PRATT & WHITNEY CANADA
SERVICE BULLETIN

P&WC S.B. No. 28404

TURBOSHAFT ENGINE
NOZZLE-ASSEMBLY TURBINE EXHAUST - REPLACEMENT OF

Summary: Brazing gaps between No. 5 cover bearing housing and oil tubes are not in line with the engineering specification. Replace No. 5 cover bearing housing with a new one that has increased holes diameter to meet brazing specification requirements.

Fits and Clearances
Figure 1

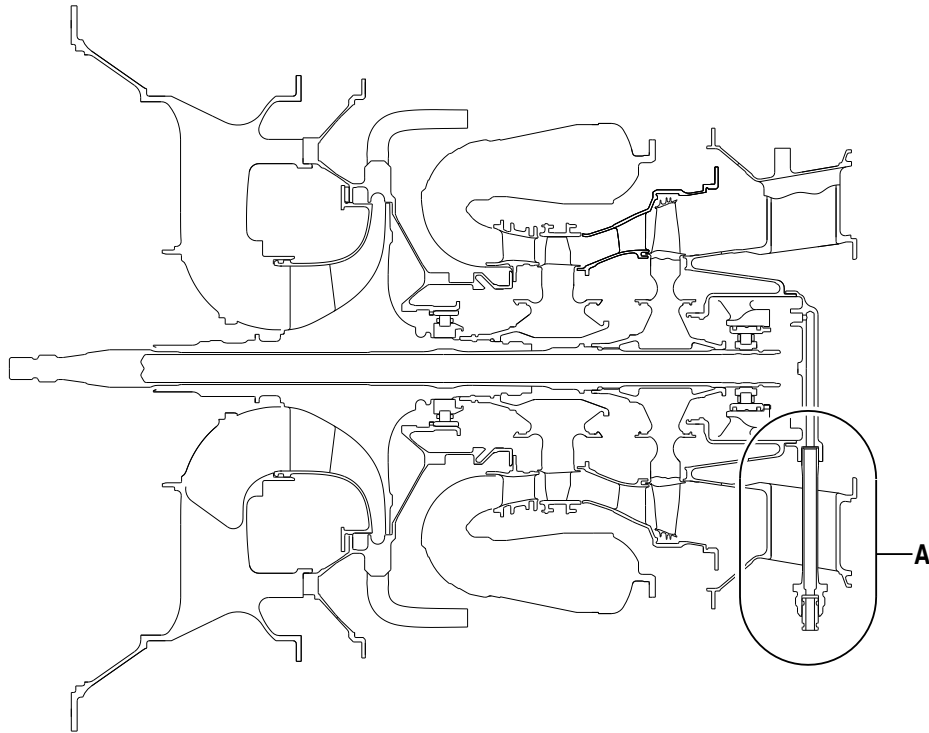
Refer to Table 1 Sheet 1and Figure 1 for Fits and Clearances.

REF. NO.	IFR	Name	Dim. for Ref. inches (mm)		Limits inches (mm)		Replace
			Min.	Max.	Min.	Max	
PRE-SB		Tube Oil No. 5 Brg.	0.4260 (10.820)	0.4275 (10.859)	0.0005 (0.013)	0.0040 (0.102)	
		Cover No. 5 Brg. Hsg.	0.4280 (10.871)	0.4300 (10.922)			
POST-SB		Tube Oil No. 5 Brg.	0.4260 (10.820)	0.4275 (10.859)	0.0025 (0.064)	0.0060 (0.152)	
		Cover No. 5 Brg. Hsg.	0.4300 (10.922)	0.4320 (10.973)

Replace No. 5 cover bearing housing with a new one that has increased holes diameter to meet brazing specification requirements.
